No. 0967
ATA Code 32-40

SUBJECT: LANDING GEAR - INSPECTION FOR VENT HOLE IN BRAKE FLUID RESERVOIR

Service Instructions No. 0967

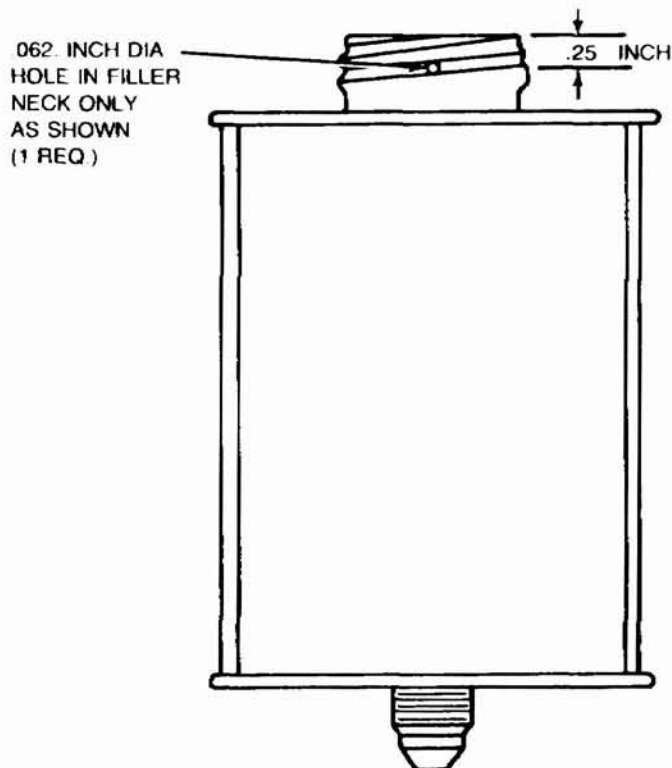
1. Remove the brake fluid reservoir cap and inspect the reservoir filler neck for a vent hole as shown in the illustration. The brake fluid reservoir is located as follows:

3. If no vent hole is found, the reservoir should be removed and the vent hole drilled

as shown in the illustration.

If the hole is to be drilled, the reservoir must be thoroughly cleaned after drilling to remove all drill burrs, etc.
